Product hierarchy no. *				Part no.	SBU	Type / Description
SBU	PG	PUG	Type			
01	001	023	0000000351	See list below	Circuit Protection	UMF 250

2 Type of change

Product Change Notification					UMF 250 10A marking		
owner	creation date	release date	released by	change order no	rev	page	D10-046-613
schmidre	22.06.2020	24.06.2020	haeckima	2020169	A	1 of 2

Old product appearance	New product appearance

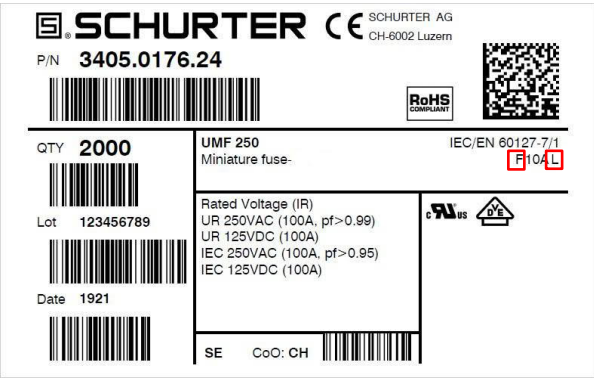
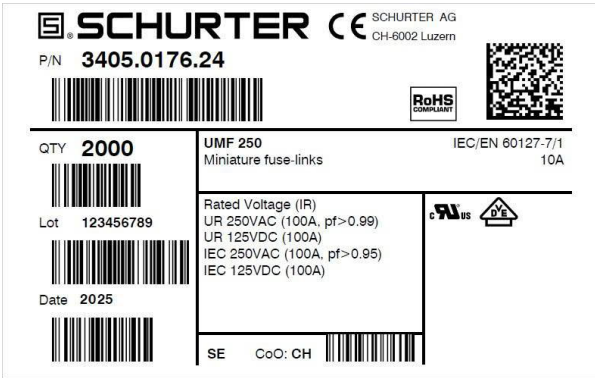
The 10A version got newly approved by VDE on the IEC 60127-7. Since this part 7 doesn't allow to use some reserved characters, we change the product marking and labels accordingly.
